# Proposal for Supplement 4 to the 01 series of amendments to UN Regulation No. 129 (Enhanced Child Restraint Systems)

### Submitted by the Working Party on Passive Safety\*

# Supplement 4 to the 01 series of amendments to UN Regulation No. 129 (Enhanced Child Restraint Systems)

Figure 3, amend to read:

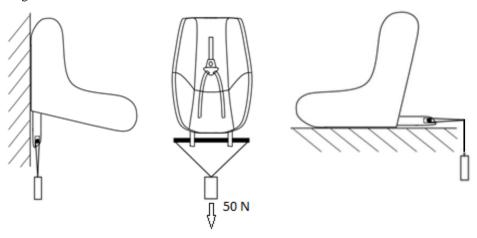
Paragraph 7.2.8., amend to read:

"7.2.8. The complete seat, or the component fitted with ISOFIX attachments (e.g. ISOFIX base) if it has a release button, is attached rigidly to a test rig in such a way that ISOFIX connectors are aligned as shown in Figure 3. A 6 mm diameter bar, 350 mm long, shall be attached to the ISOFIX connectors. A force of  $50 \pm 1$  N shall be applied to the extremities of the bar."
